REQUEST FOR TECHNICAL REVISION (TR) COVER SHEET

File No.: M- 1976-056 Site Name: Riverside Pit

RE: Riverside Pit - M-1976-056
Technical Revision - Flood damage

RECLAMATION PLAN MAP - TECHNICAL REVISION MAP 5-15A

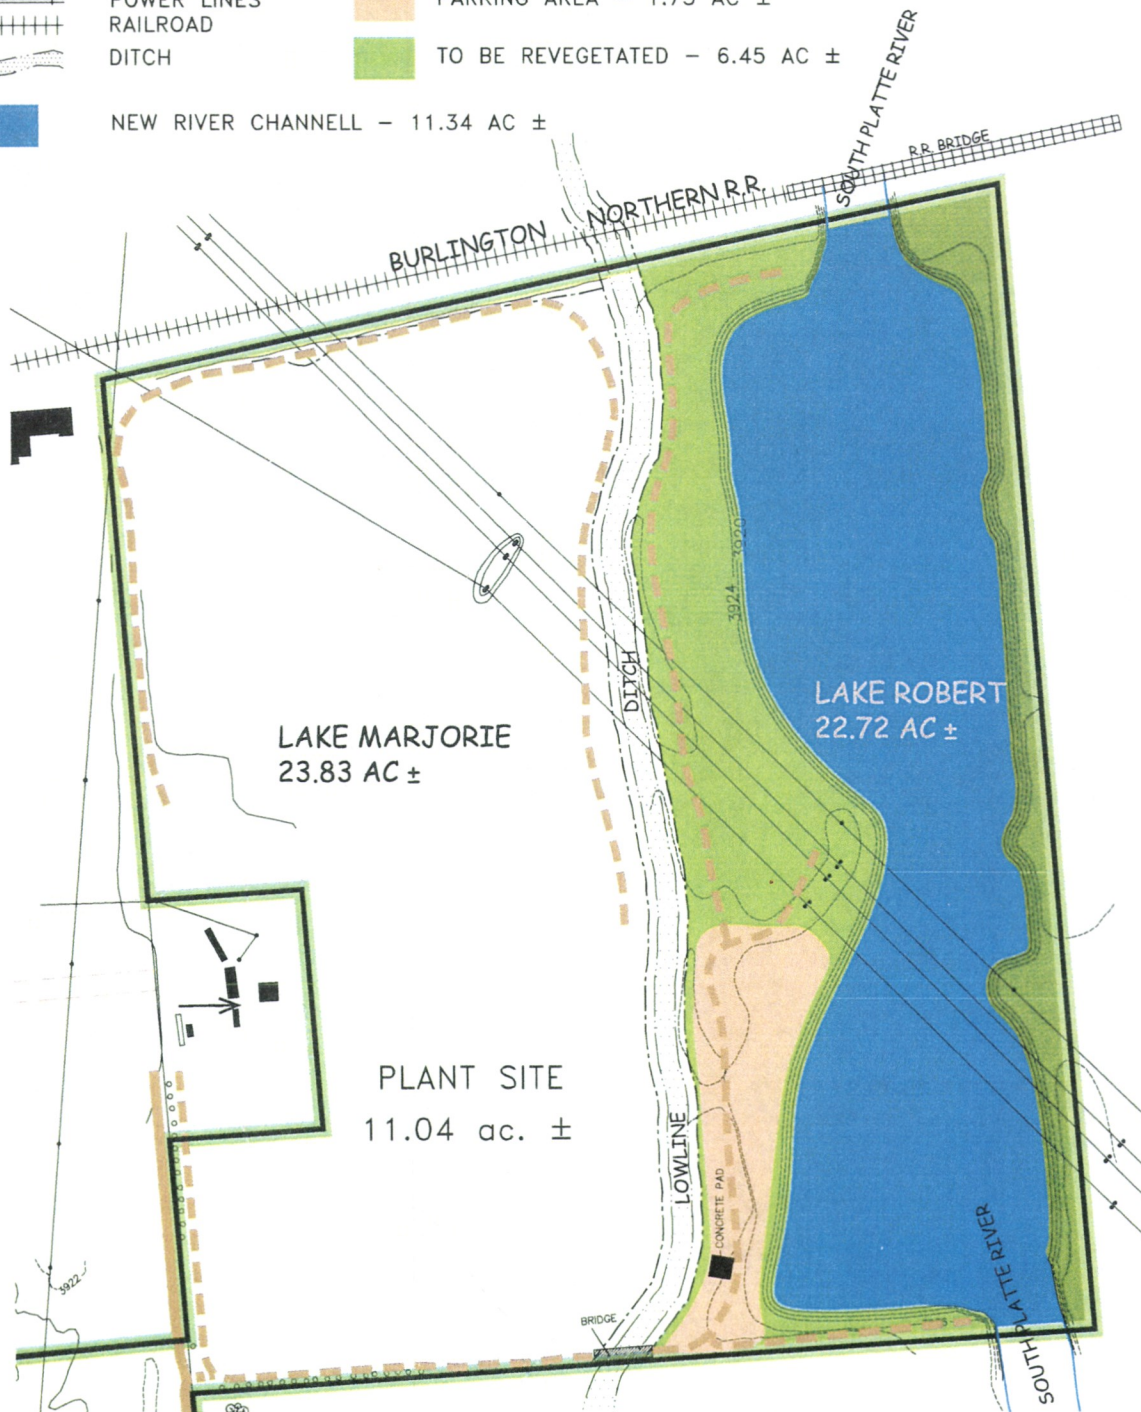
McAtee Construction Company is submitting this Technical Revision to make a minor change to the Reclamation Plan. The reason for this change is the result of damage done by the September 2013 flood that affect the South Platte River in the Sterling area. Attached is a revised **Reclamation Plan Map** for the Lake Robert area showing how the area will be reclaimed if this Technical Revision is approved. It changes the approved Reclamation Plan on the area east of the west bank of the new active river channel in the Lake Robert area only. No further reclamation is proposed on that area.

Lake Robert was nearly completely reclaimed prior to the flood but, there was some work left along the west side that was being used to store sand and equipment. Much of this was damaged during the flood. Since A nature event (Flood) reshaped and reclaimed the 2.50 acre \pm east of the river channel and the area is inaccessible unless we cross the river this area will not be changed again (dark green on map). McAtee Construction Co. will not do any work in the 11.34 acres \pm of the new river channel (blue on map) with the exception, that the Company that owns the power lines may place armoring along areas of the west bank to protect the power poles. If this is done it will be done but the power company under a Corps of Engineers permit if needed. The location of this armoring is unknown at this time as the power company has not advised us what their protection plans are.

The west area contains 6.45 acres \pm that will be reclaimed as approved in the current Reclamation Plan. Vegetation will be restored on the areas damaged by flooding, property access roads, 0.68 acres \pm , will be kept to provides access around the west side of the river channel and to the power poles on the west. We also intend to leave a graveled parking area, 1.75 acres \pm , the access bridge over the Lowline Ditch and the access road to the parking area.

The current conditions of the Lake Robert Area can be broken into 2 areas separated by the new river channel. The eastern side, for which there is no access without crossing the river, and the western side still accessible via the original access road. Review of the attached **Reclamation Plan Map - Technical Revision Exhibit 5-15A** shows the areas as discussed below.
